LICENSEES' ANSWER  
PROTESTING CIVIL PENALTY

Your letter of May 23, 1984 transmitting the "Interim Report on Protective Coatings" prepared by Brookhaven National Laboratory and dated April 25, 1984 requested additional information (identified in Section III of the report) in order to complete your review. While the information requested is generally available or obtainable and can be transmitted to you or reviewed on site at your request, we would like to propose an alternate approach.

COMANCHE PEAK STEAM ELECTRIC STATION  
UNITS 1 AND 2  
BROOKHAVEN INTERIM REPORT ON PROTECTIVE COATINGS  
FILE NO. 906.1, 10010

COMANCHE PEAK STEAM ELECTRIC STATION  
UNITS 1 AND 2  
BROOKHAVEN INTERIM REPORT ON PROTECTIVE COATINGS  
FILE NO. 906.1, 10010

SHEET 1 OF 2  
NO. PC 1-0027219

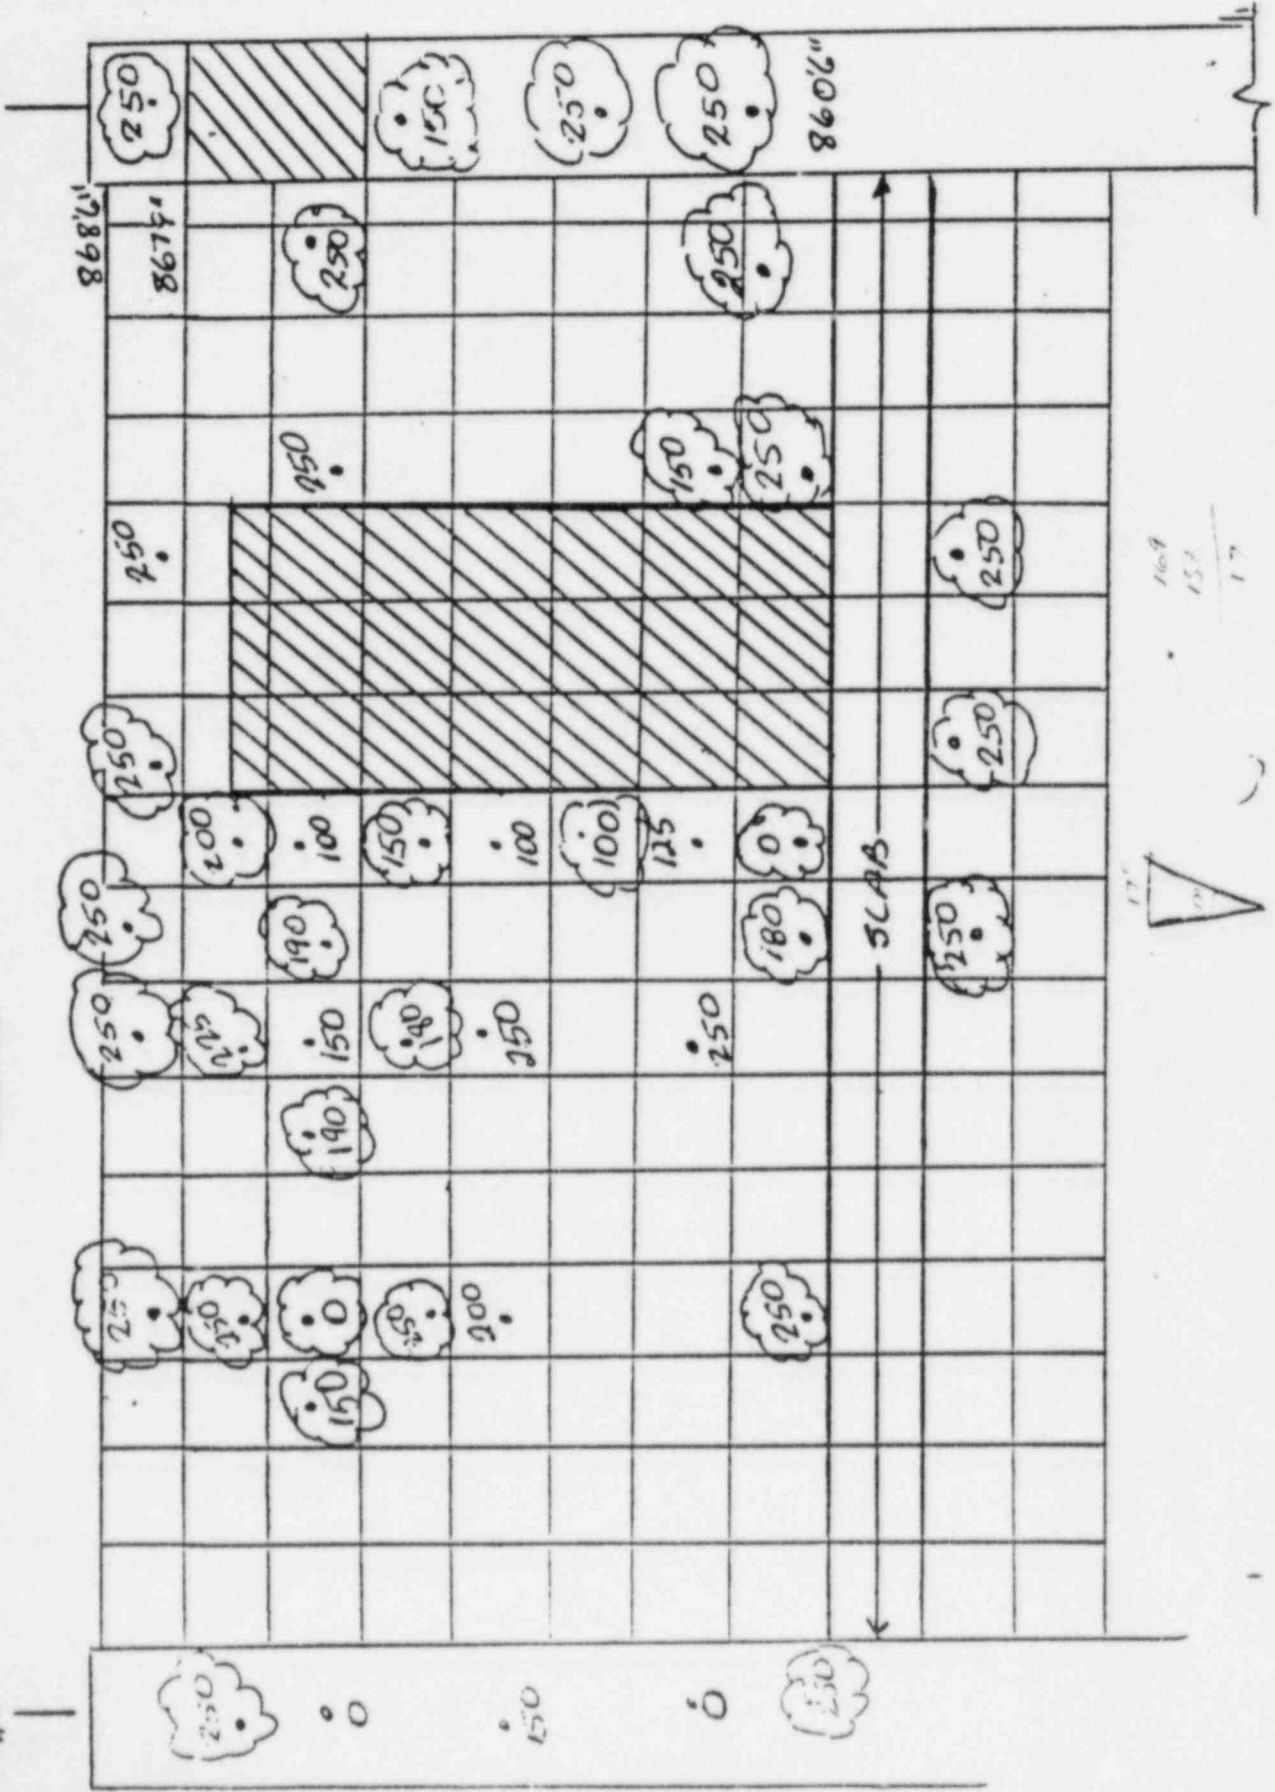
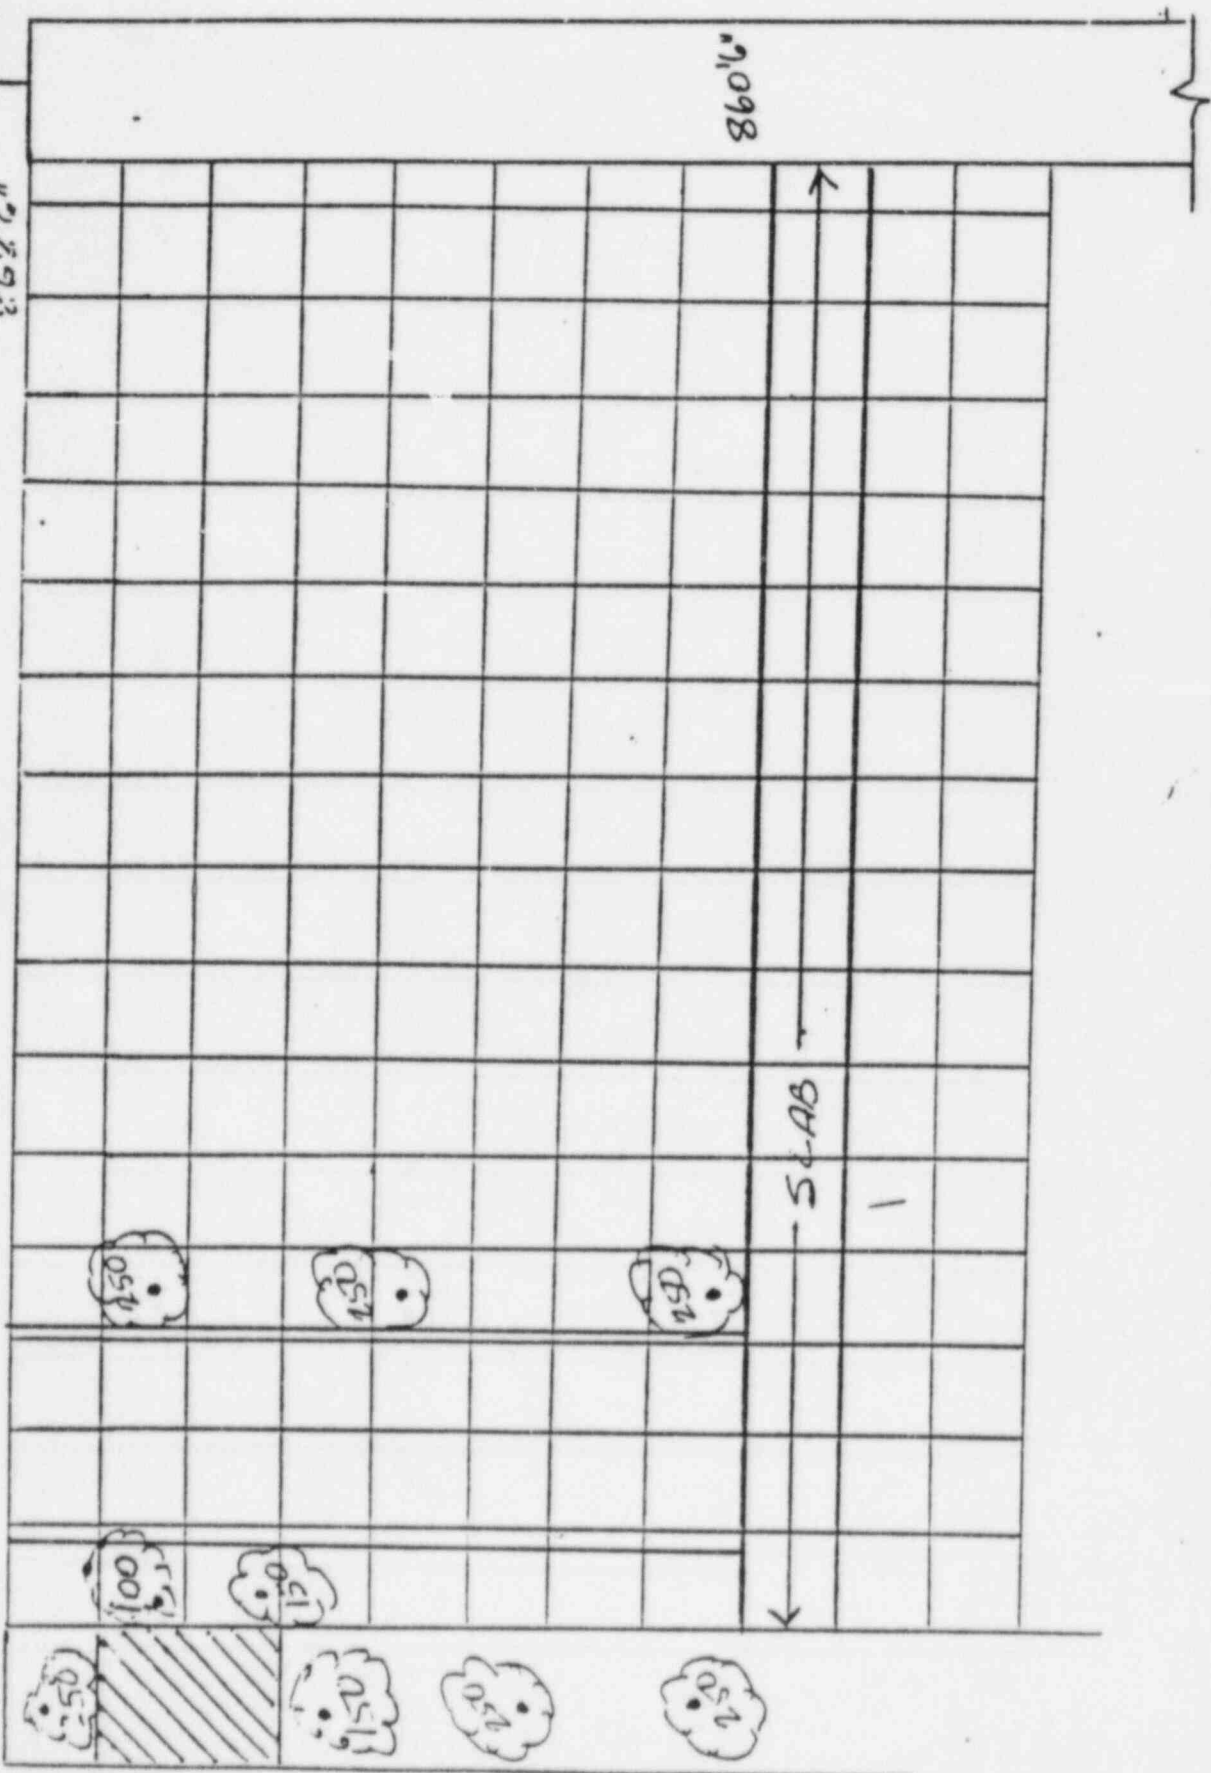
BNL's observed failure rate for the liner plate is unacceptable. Although it was limited in scope, it raises questions about the adequacy of the Backfit Program for the liner plate.

- 2) The area under the equipment hatch (approximately Azimuth 225° and Elevation 813') where three of the four adhesion values were less than 200 psi (actual recorded readings were 150, 180 and 180 psi), had not been included in the backfit program because this area had not been painted at the time the backfit program was implemented. Furthermore, the BNL test results were classified as nonconforming via NCR C-84-00921. Additional testing clearly show the lower values obtained by BNL to be extremely isolated and of no consequence.

- 1) BNL has apparently expanded the scope of the backfit program beyond that intended and documented by Applicants. A review of Applicants response to NRC I&E Report 81-15 as well as the backfit procedures clearly establishes the backfit program scope. It was designed to establish confidence in coatings that had been applied prior to late 1981 (where inspection records were incomplete) and not as a measure of coatings application activities accomplished since late 1981. These latter activities have been accomplished and fully documented in accordance with the established QA program.

Contrary to the finding by BNL, results of the backfit program demonstrate adequacy of the liner plate coatings. (See Response III. D.11 and III. D.12, TXX-4225 dated July 16, 1984).
